MEMORANDUM

DATE May 30, 2019
TO Erick Serrano, Associate Planner, City of Cupertino
FROM Terri McCracken, Associate Principal, PlaceWorks
SUBJECT Cupertino Village Hotel Project Initial Study and Mitigated Negative Declaration Responses to Comments Memo

Table 1 Responses to Comments on the Public Review Draft Initial Study and Mitigated Negative Declaration

Figure 1. Examples of eBird sighting records (blue teardrops) in the project (red polygon) area, including Cooper's hawk, sharp-shinned hawk, red-shouldered hawk, and Nuttall's woodpecker.

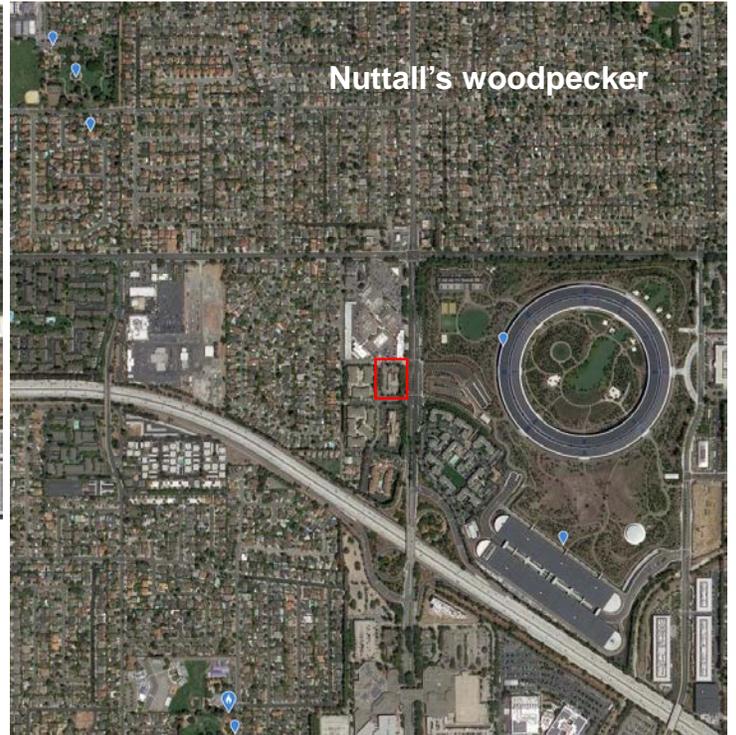
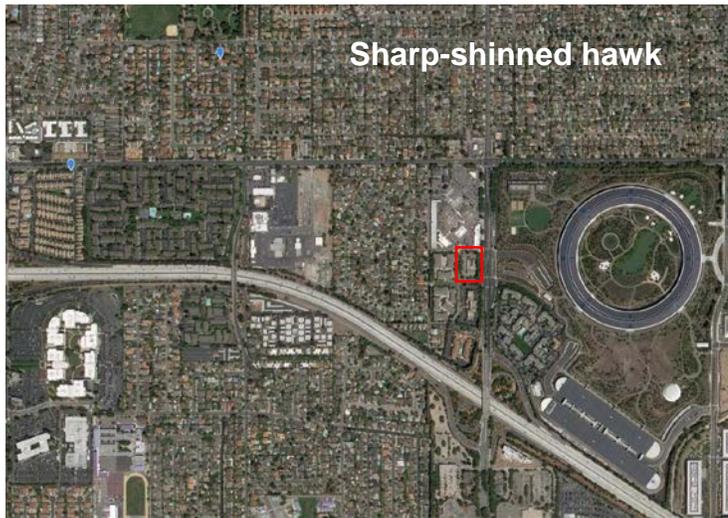
Reviewing occurrence records and geographic range maps, I identified 26 special-status species of wildlife potentially using the site at one time or another, including 5 bat species (Table 2). eBird records confirmed the Apple Campus’s open space draws special-status species of birds, as exemplified in Figure 1, but birds also make use of the wider urban environment, likely for stop-over during migration or dispersal. The use of the area by special-status species, and the vulnerability of 6 of the species to window collisions, warrants preparation of an EIR.
